Office Action Summary	Application No. 10/735,440	Applicant(s) KOLLMANN ET AL.	
	Examiner Charles E. Phillips	Art Unit 3751

APPLICATION NO.	FILED DATE	FIRST NAMED INVENTOR	ATTORNEY DOCKET NO.	CONFIRMATION NO.
10/735,440	12/12/2003	Fabian Kollmann	3201-366 (D4700-00380)	2028
7590 STEPHAN P. GRIBOK DUANE MORRIS LLP ONE LIBERTY PLACE PHILADELPHIA, PA 19103		11/15/2007	EXAMINER PHILLIPS, CHARLES E	
			ART UNIT 3751	PAPER NUMBER
			MAIL DATE 11/15/2007	DELIVERY MODE PAPER

SN 10/735,440
Substitute Drawing

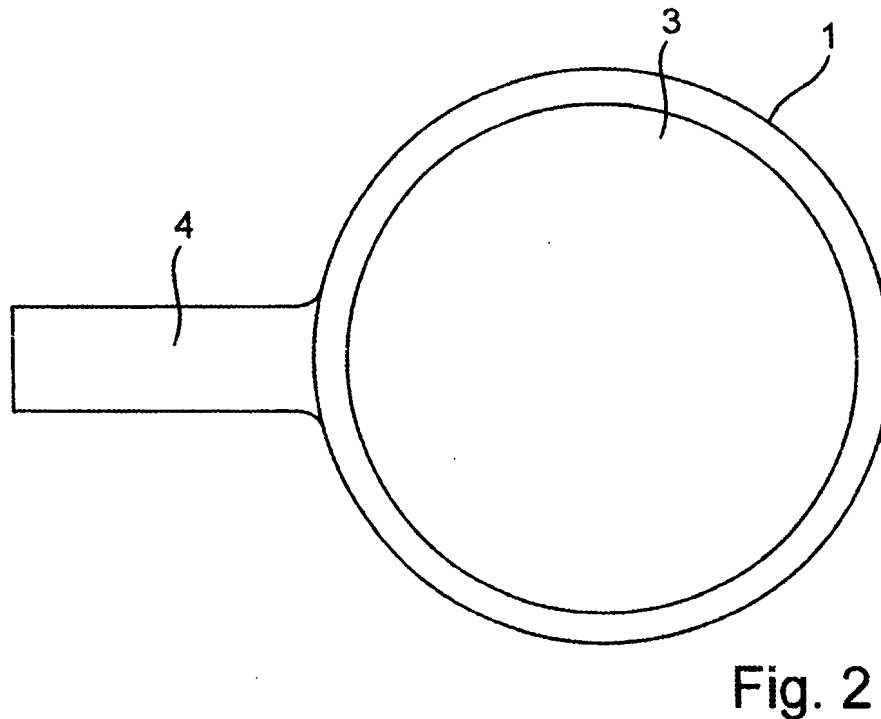
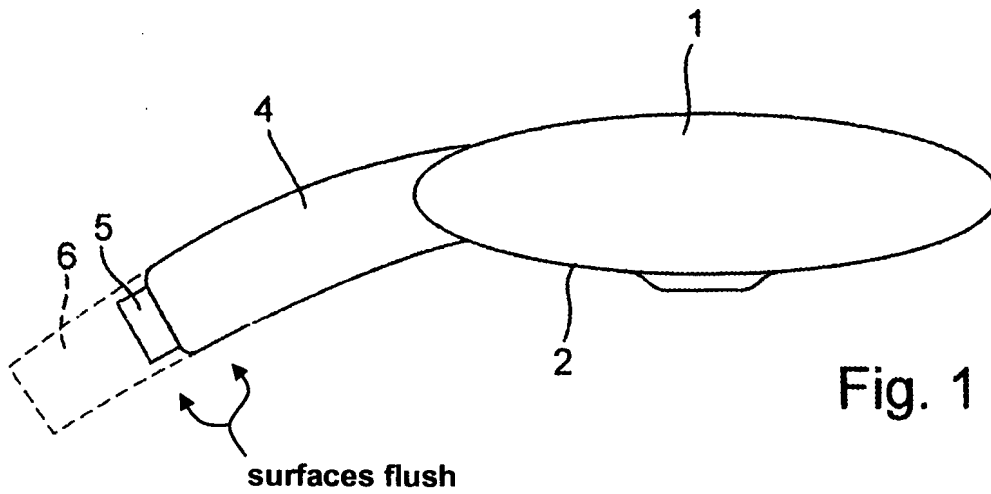
The proposed drawing correction filed on 9/28/07 is disapproved as the depiction of the union nut is inconsistent with that of the original drawings in that the double lines at the hose end are lacking, the fitting is of a different shape and the terminal end of the handle is rounded.

not approved
11/9/07 CEP
